ADDENDUM NO. 2

PROJECT: Cross Charlotte Trail – Orr Road to Rocky River Road
Project No.: PMES171522
Bid Number: HC2023-1195

Greenway Phase 2 Soldier Pile Wall Finish

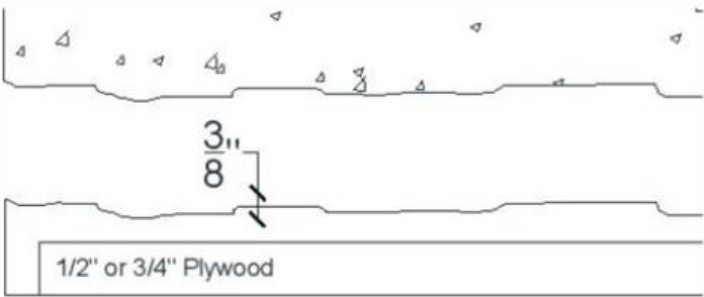
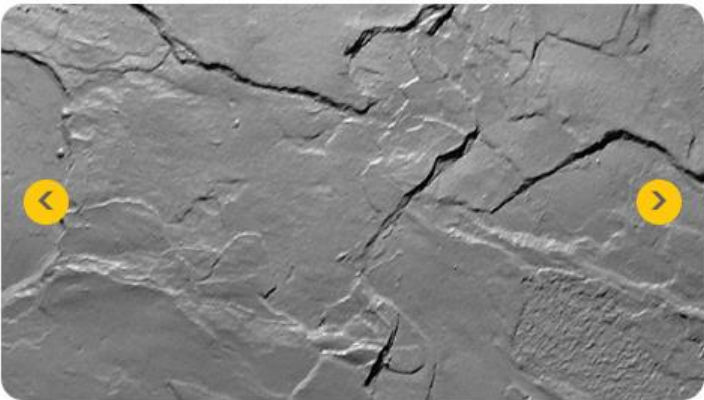
Exact coping dimensions are not provided in the plans. What is the desired finish of the precast concrete panels? Is brick veneer required? More information should be provided to the bidders, so we are all bidding the walls the City is expecting as a finished product.

Contractor to provide the City with options for finish during construction, desired finish is to be similar to the attached example. Soldier pile wall detail (Detail #2, Sheet 2E) has been updated to include a call out indicating the panels are to have a textured finish.
